1984 Corvette: Campaign: Power Steering Pump Pulley Failure

Number: 84C03

Subject: P/S Pump Pulley Failure

TO: ALL CHEVROLET DEALERS

DISCONTINUED VS. REVISED PULLEY

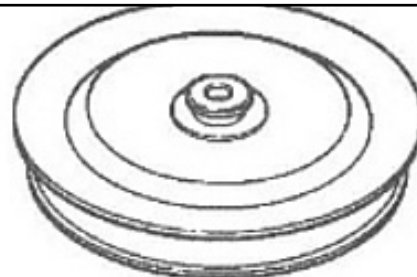
General Motors has determined that certain 1984 Chevrolet Corvettes are equipped with power steering pump pulleys which may crack at the outer edge. Continued operation may cause the pulley to break, resulting in loss of the drive belt. If the pulley cracks, vehicle occupants should be alerted by a rattling sound coming from the engine compartment.

Power steering pump pulley, P/N 14055114, required to complete this campaign will be shipped directly to the dealers' Service Manager from Chevrolet Central Office. Parts quantities will be determined by the number of vehicles identified on the computer list furnished each involved dealer with the campaign bulletin. Dealers are to install these pulleys only on vehicles within the parameters outlined in this bulletin.
